PREVIOUSLY APPROVED
NEIGHBORING PROJECTS

RESIDENTIAL DEVELOPMENT
1165 GREACEN POINT ROAD
MAMARONECK, NY, 10543

**1 SHORE ROAD
Adopted May 20, 2020**

RE: Site Plan Approval
Nauset, LLC
1 Shore Road
Section 155.61, Block 1, Lot 9

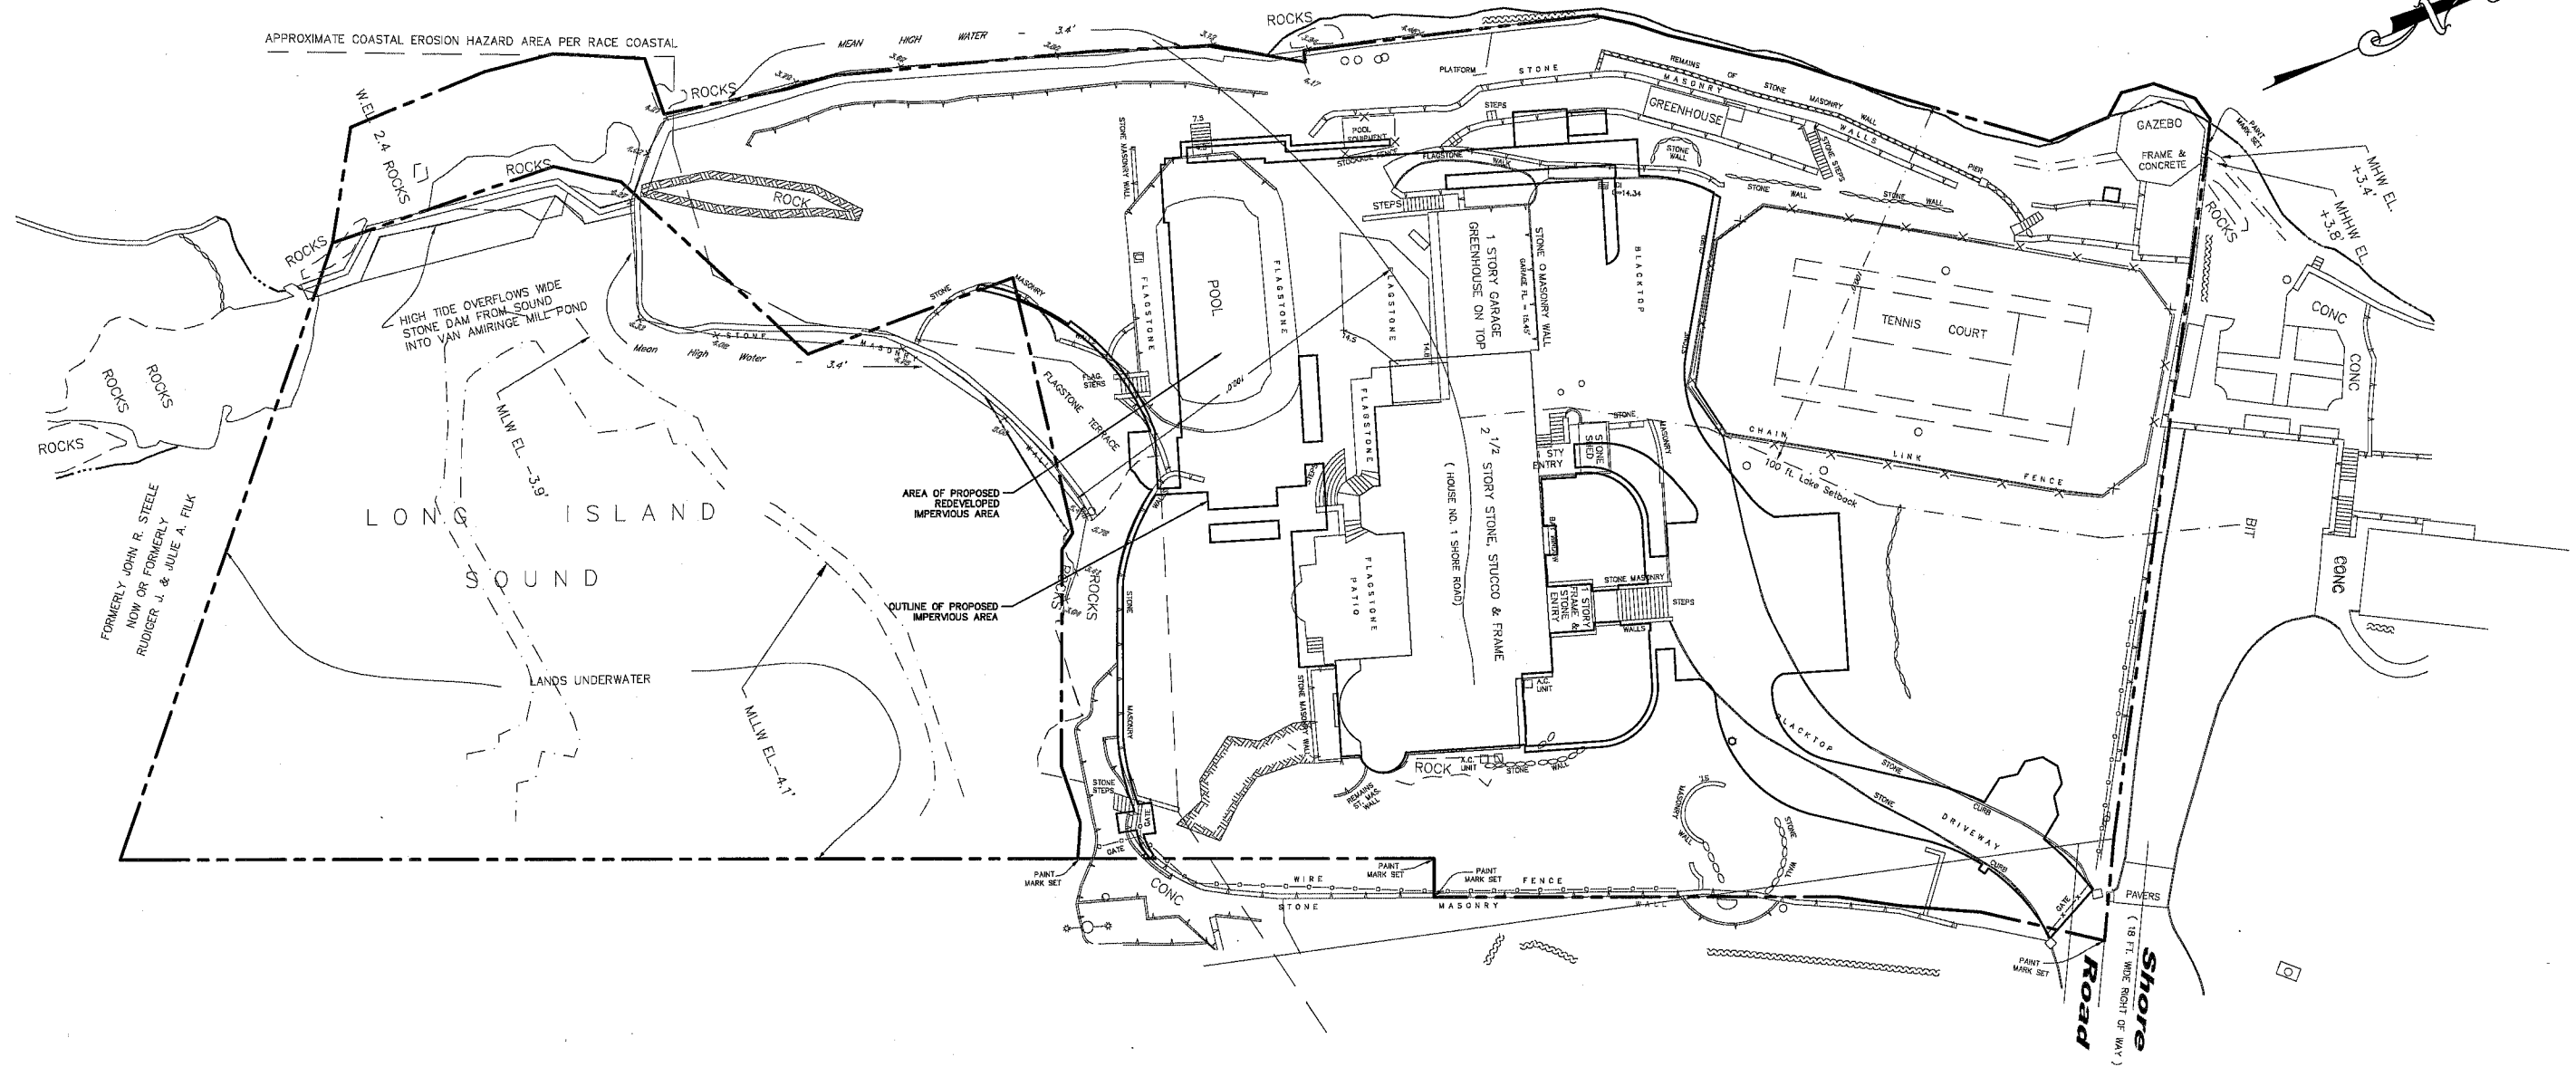
- In Section E "Runoff Volume & Water Quality Volume", the Applicant shall revise the impervious areas used in the calculations to be consistent with the area takeoffs noted on Sheet C-2 (i.e., redeveloped and newly developed impervious areas).

1 SHORE ROAD GRADING & DRAINAGE PLAN BASED UPON EXISTING INFORMATION PROVIDED BY WARD CARPENTER ENGINEERS INC., DATED MARCH 30, 2017

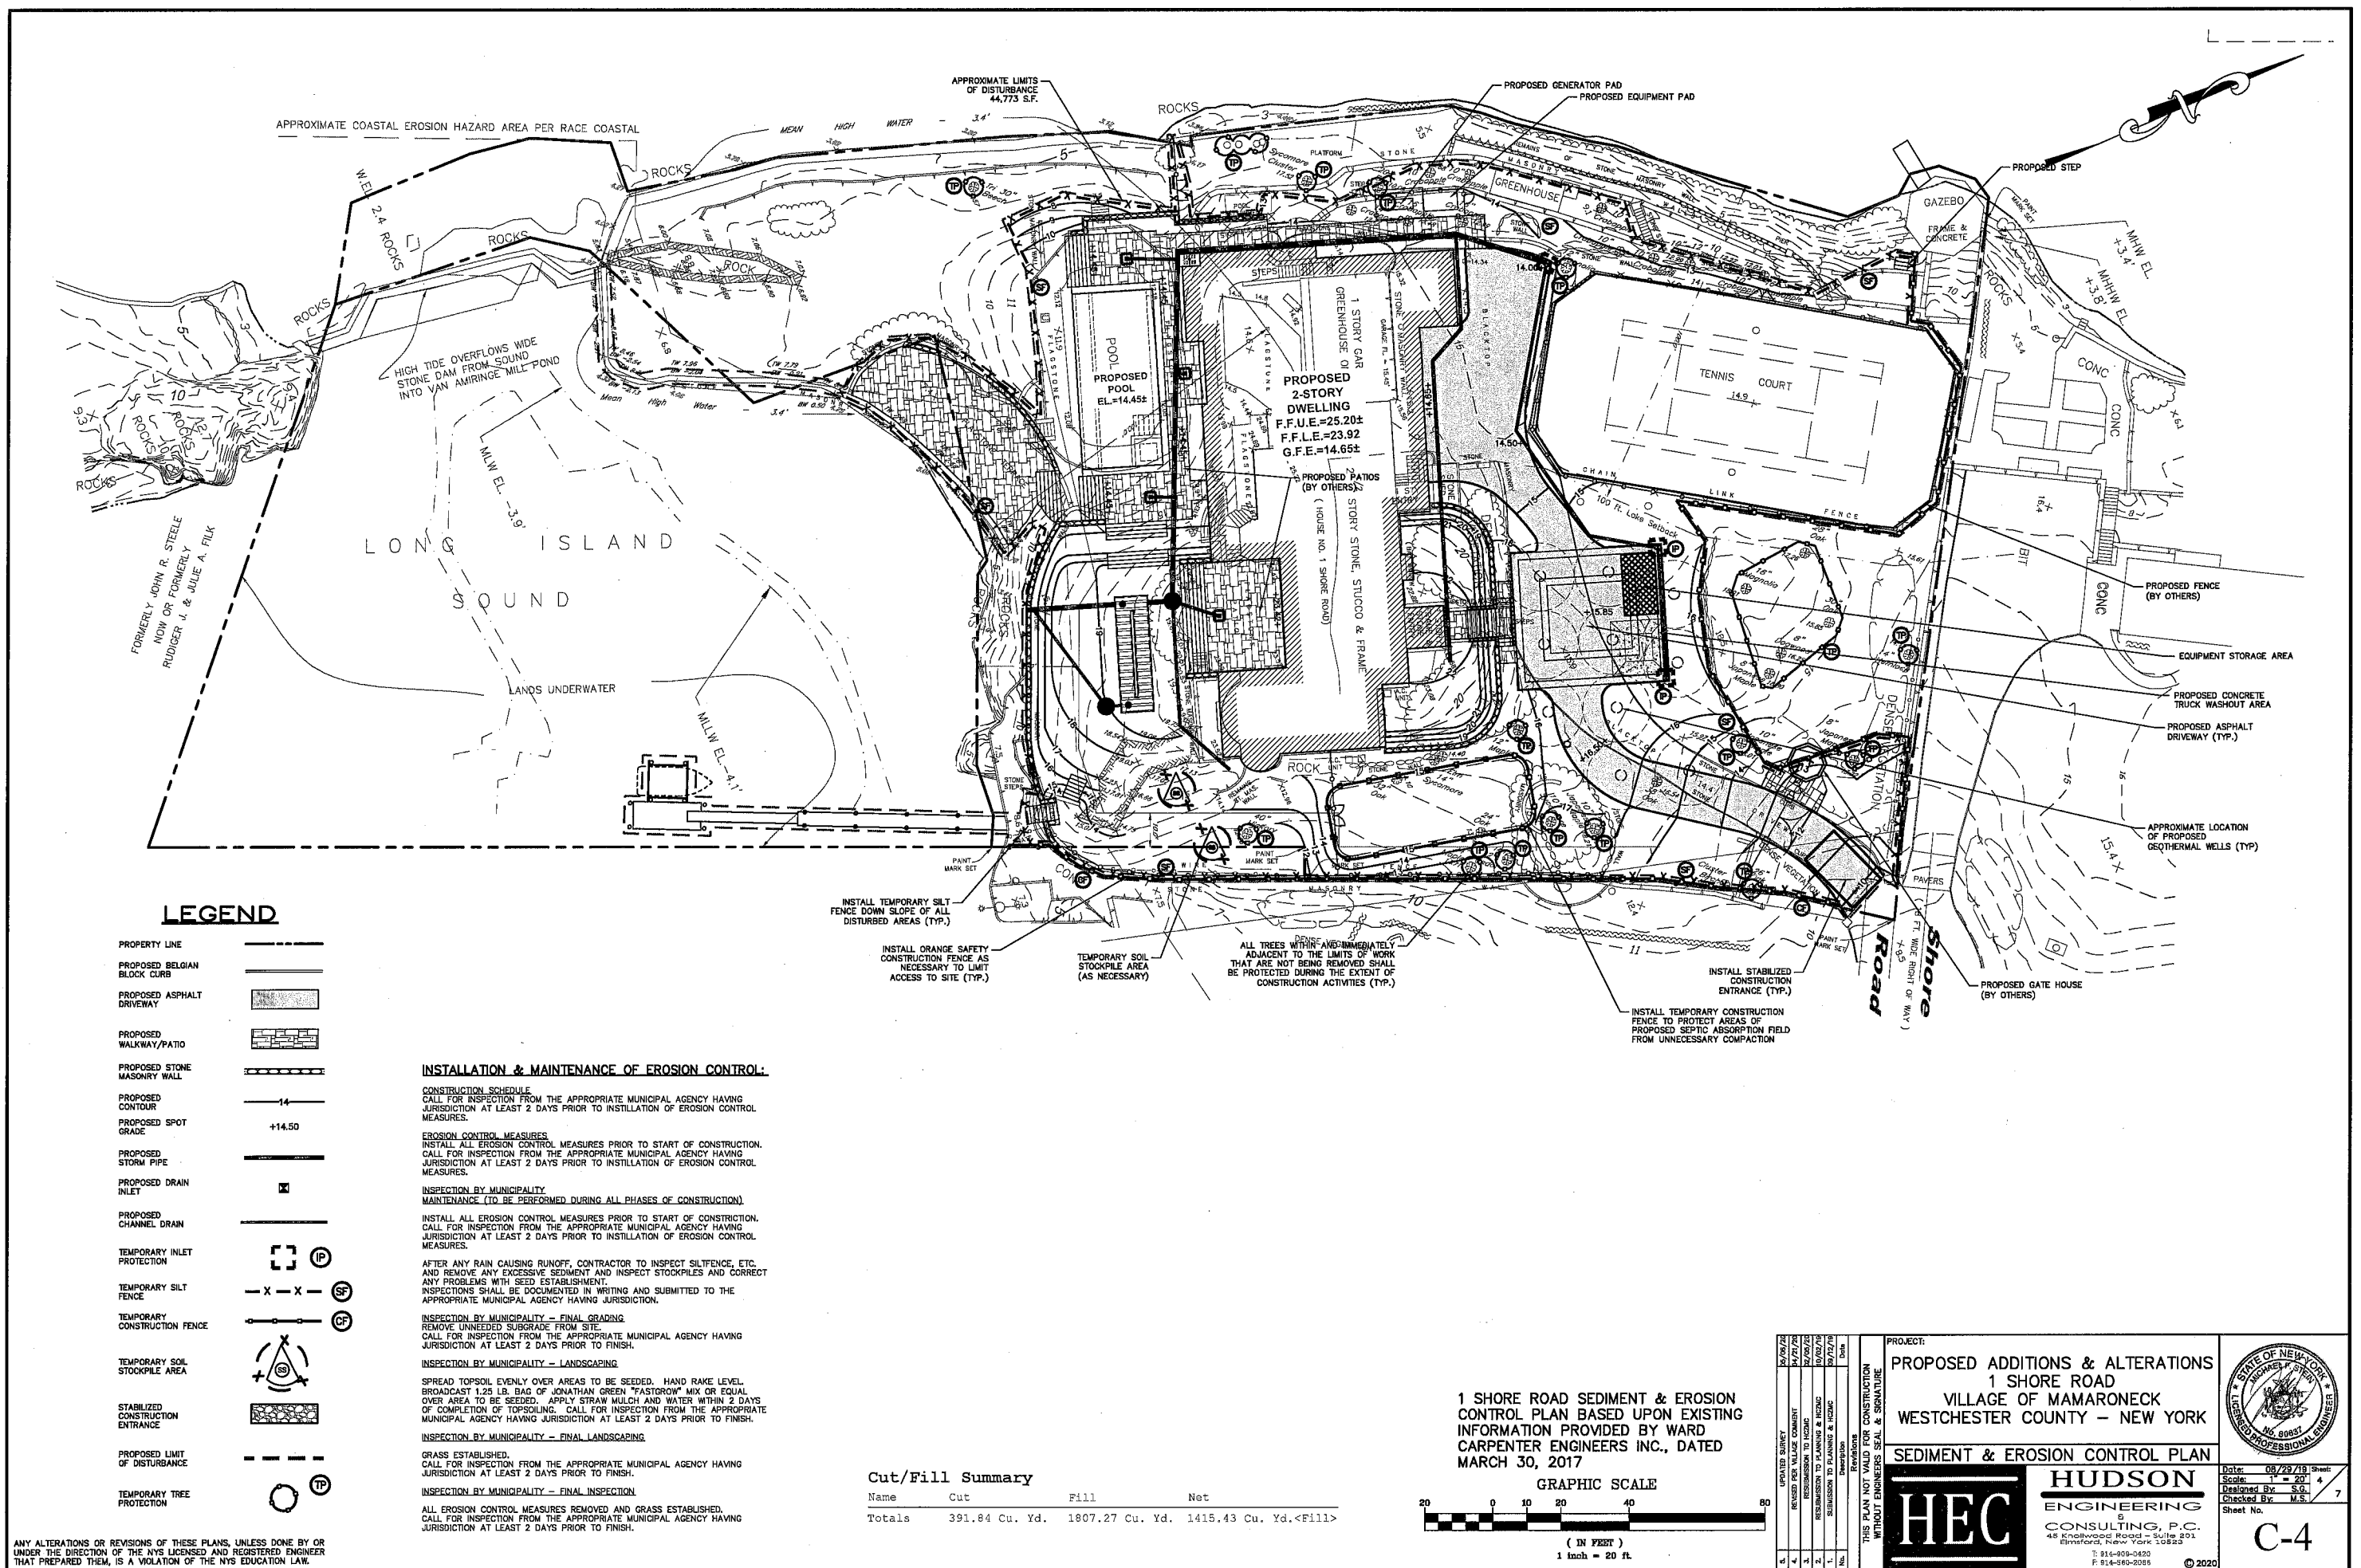
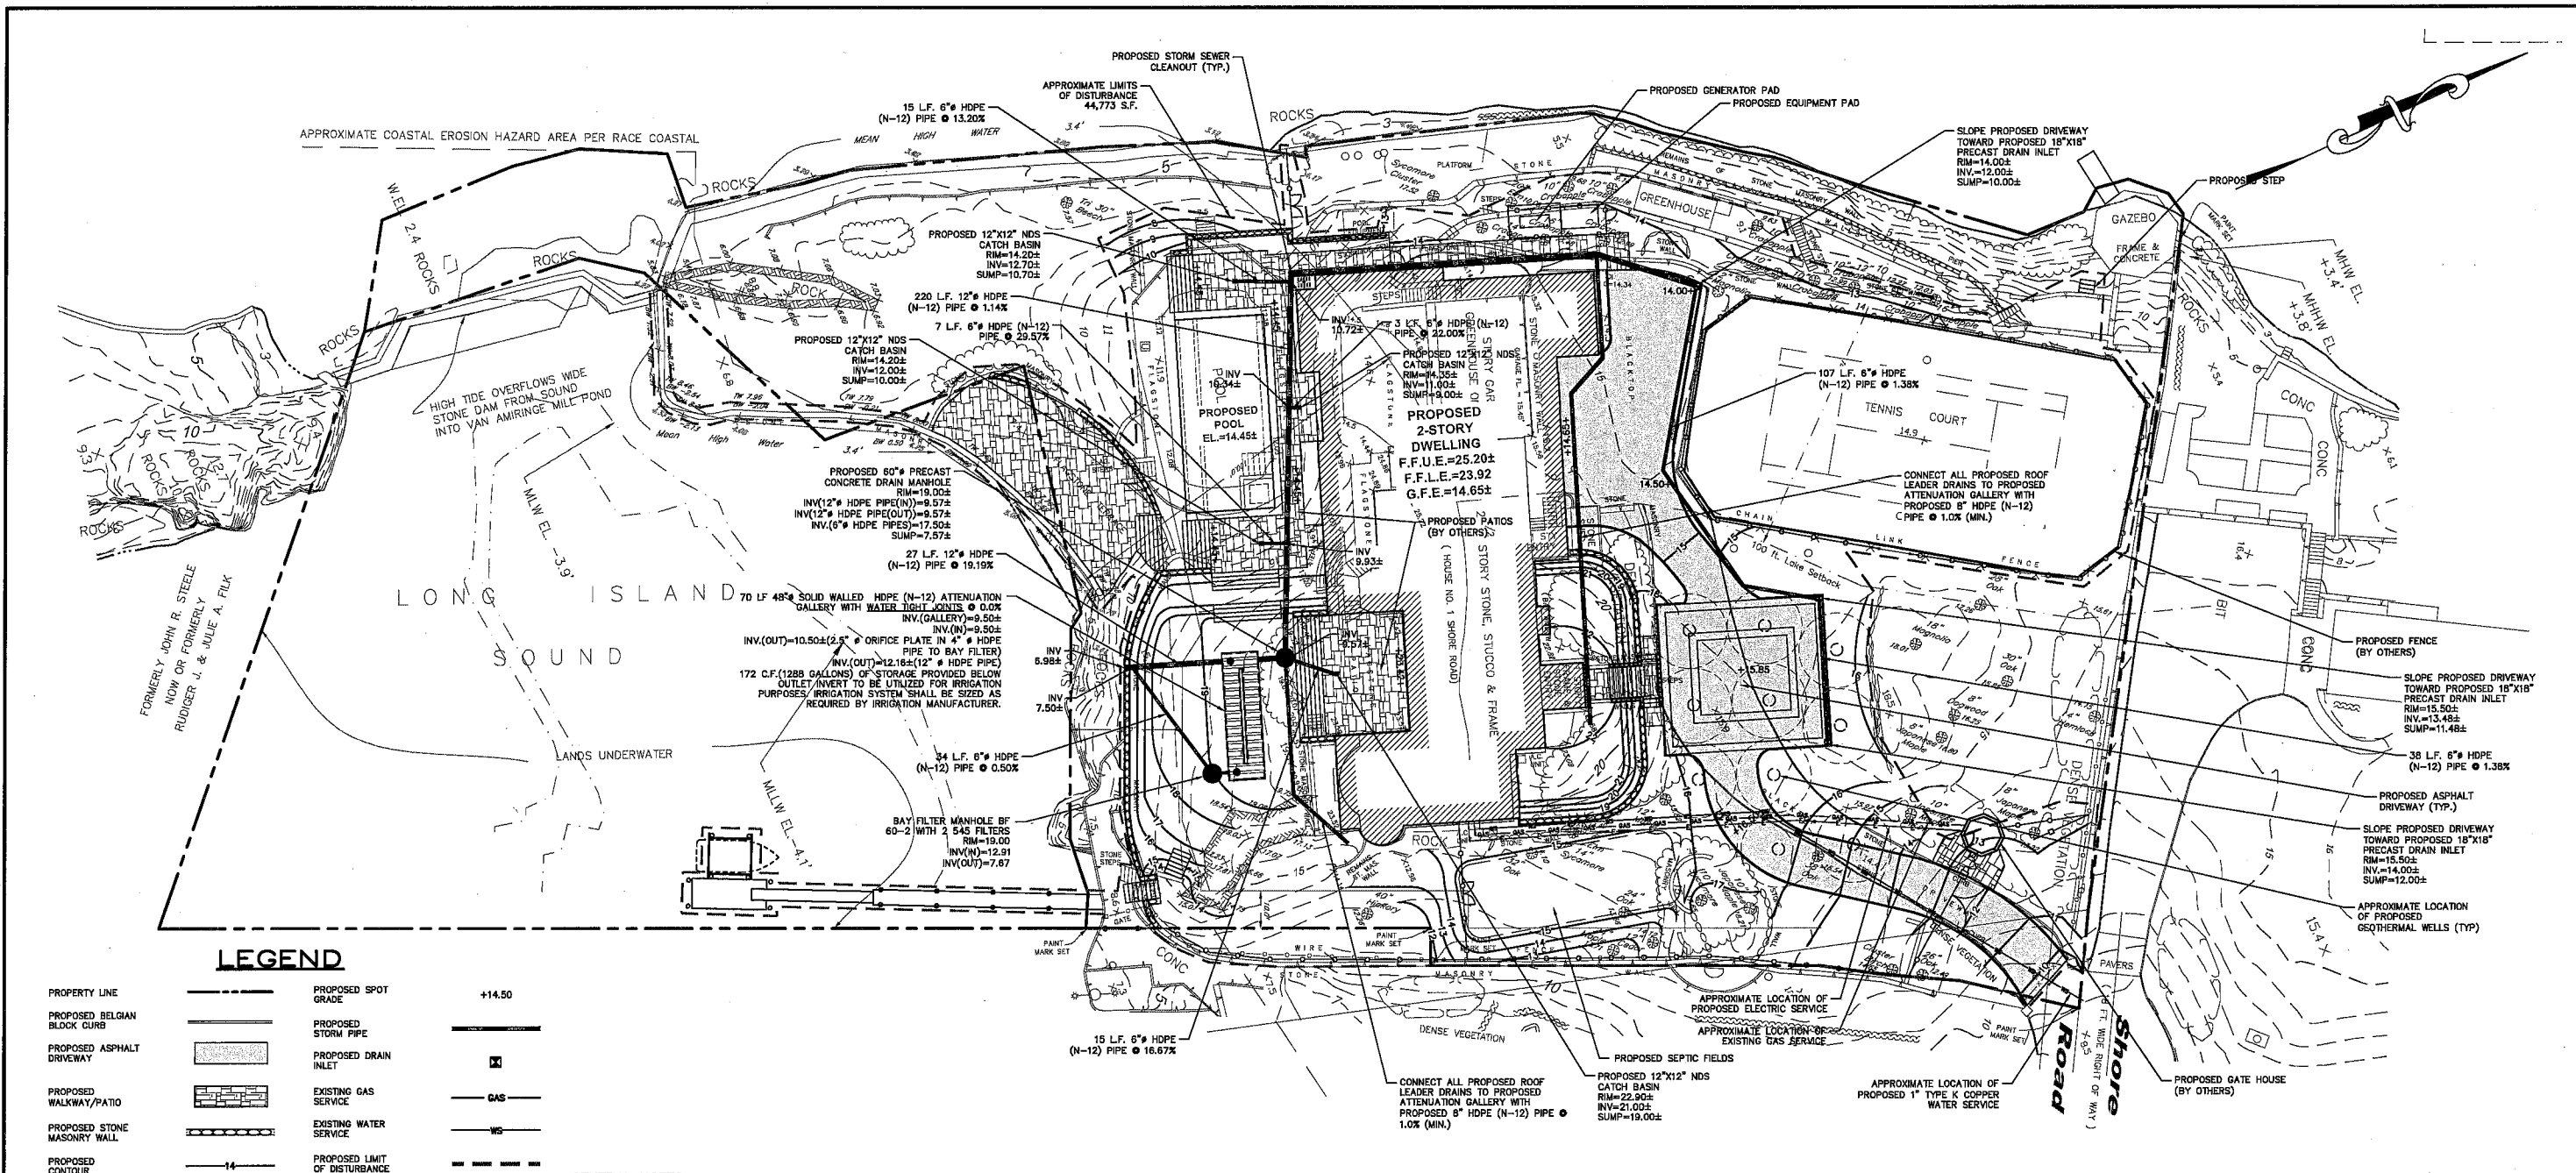
6. The applicant shall quantify in a table on the plans the proposed cut/fill volumes (quantified in cubic yards) for the proposed improvements. Note that cut/fill estimates shall be balanced, or an excess cut shall be proposed because the project site is located within the 100-year Floodplain and net filling is not allowed.

Addressed. The provided analysis demonstrated a 1,415 c.y. net fill. Therefore, the applicant is seeking a variance from the Planning Board. The Applicant has prepared a floodplain impact analysis (submitted February 2020) that demonstrates the floodwater levels will not be negatively impacted by this project.
